Project	IEEE 802.16 Broadband Wireless Access Working Group < http://ieee802.org/16 >	
Title	AI for interference threshold description	
Date Submitted	2007-07-09	
Source(s)	Wu Xuyong Huawei, Huawei Industry Base, Bantian, Longgang, Shenzhen, China 518129	Voice: +86-755-28976776 Fax: wuxuyong@huawei.com ,
Re:	IEEE 802.16-07/013 : Task Group Review: Working Group Draft P802.16h/D2b (2007-06-19)	
Abstract	AI result according to the group resolution in meeting #49.	
Purpose	To consolidate the 16h draft.	
Notice	This document has been prepared to assist IEEE 802.16. It is offered as a basis for discussion and is not binding on the contributing individual(s) or organization(s). The material in this document is subject to change in form and content after further study. The contributor(s) reserve(s) the right to add, amend or withdraw material contained herein.	
Release	The contributor grants a free, irrevocable license to the IEEE to incorporate material contained in this contribution, and any modifications thereof, in the creation of an IEEE Standards publication; to copyright in the IEEE's name any IEEE Standards publication even though it may include portions of this contribution; and

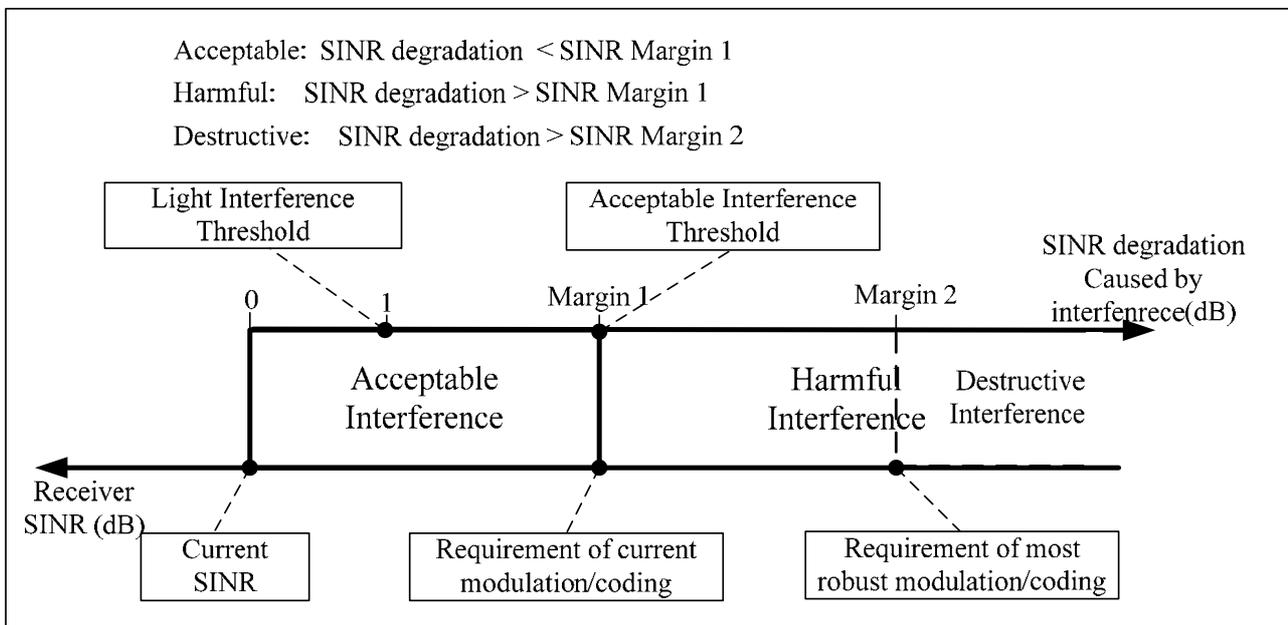
However, we have collaborative mechanisms in current project to make enhancement on the coexistence performance. So we should tell apart the different interference source once collaborative mechanism was implemented. Here is one potential strategy:

- 1) For the interference source which will not have throughput impact on current link (called **acceptable interference**), the SS will ignore its existence even if the SS have detect such interference;
- 2) For the interference source which will force the link to choose slower modulation/coding method (called **harmful interference**), the SS should detect the interference source and identify it, and report it to the its serving BS;
- 3) For the interference source which will cause the link to be fail (called **destructive interference**), the SS must detect the interference source and identify it, and report it to its serving BS as long as the linkage still exist.

Figure hxx Different level of interference and threshold

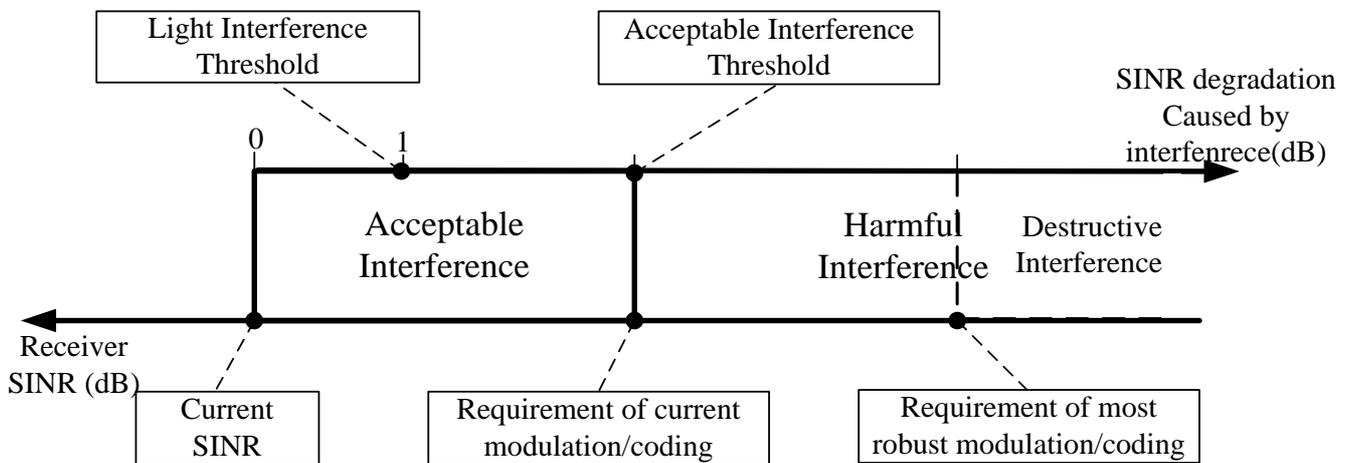
Thresholds are defined as the boundaries between the levels mentioned above. The following thresholds were defined for different actions:

- *Light Interference Threshold*, is the boundary ~~between the non-harmful interference range and the light interference range set for a receiver to recognize its interference situation when it does not have any link to other stations yet.~~ This threshold is defined as a noise-interference rise of 1db, which corresponds to an interference signal of interference to noise ratio I/N= -6dB. This threshold is used to recognize the existence of an interfering WirelessMAN-CX source, with which coordination can be performed.

- *Acceptable Interference Threshold*, is the ~~boundary between the light interference and highest level of acceptable interference ranges.~~ This value is used for recognizing a non-SSU interference source, ~~therefore to recognize the existence of neighbor systems.~~

- *Destructive Interference Threshold* is the lowest level of Destructive Interference which will disable the normal communication to the receiver.
